EPC STORMWATER REVIEW COMMENTS
IN ORANGE BOXES WITH BLACK TEXT

FINAL DRAINAGE REPORT FOR RETREAT AT TIMBERRIDGE FILING NO. 3

CCES Responses

Job No. 1185.30

36" STORM SEWER OUTFALL 100YR HGL

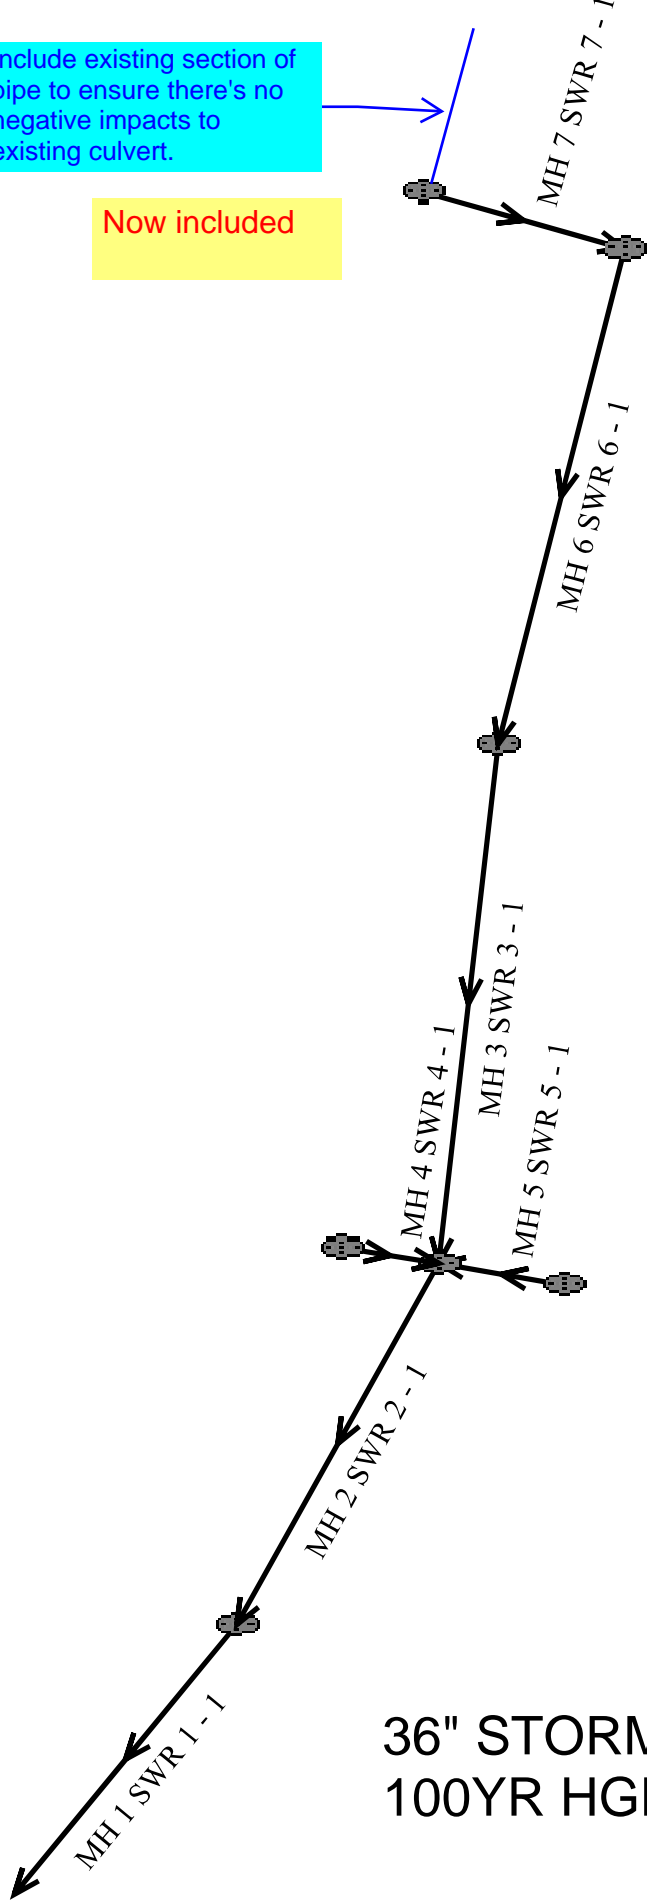
Include existing section of pipe to ensure there's no negative impacts to existing culvert.

Now included

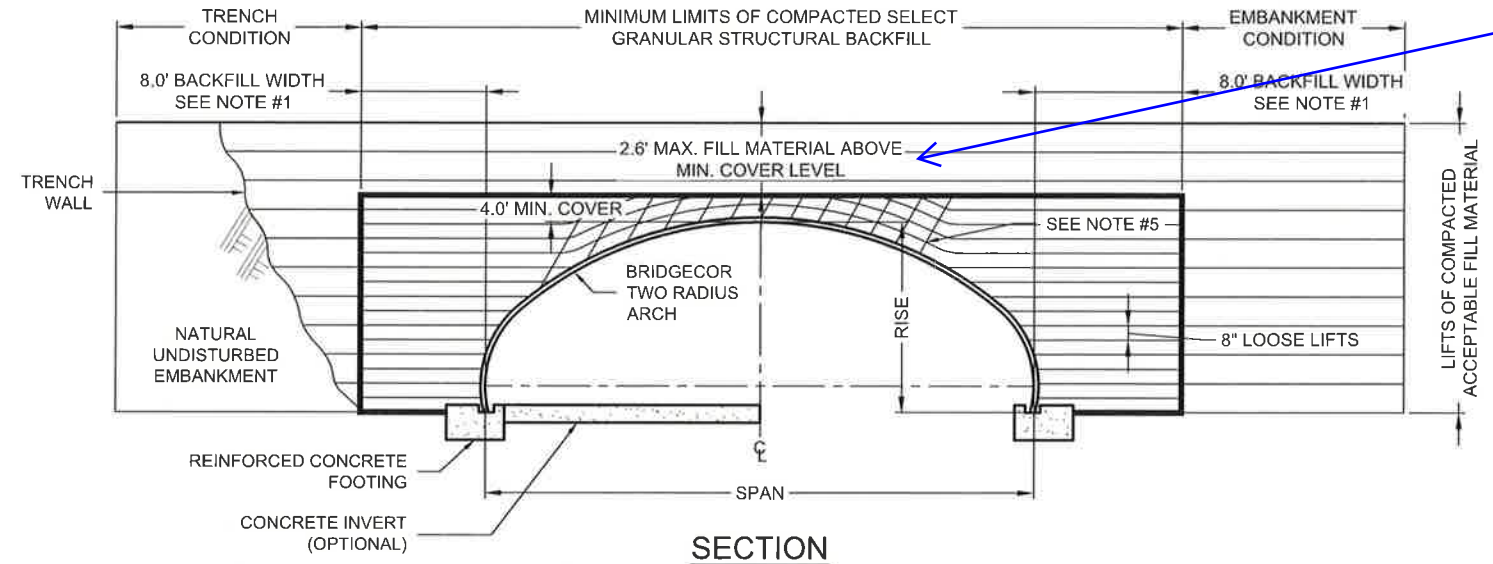
Also provide a cross section showing water and gas line crossings.

See revised headwall/wingwall plans for crossing info.
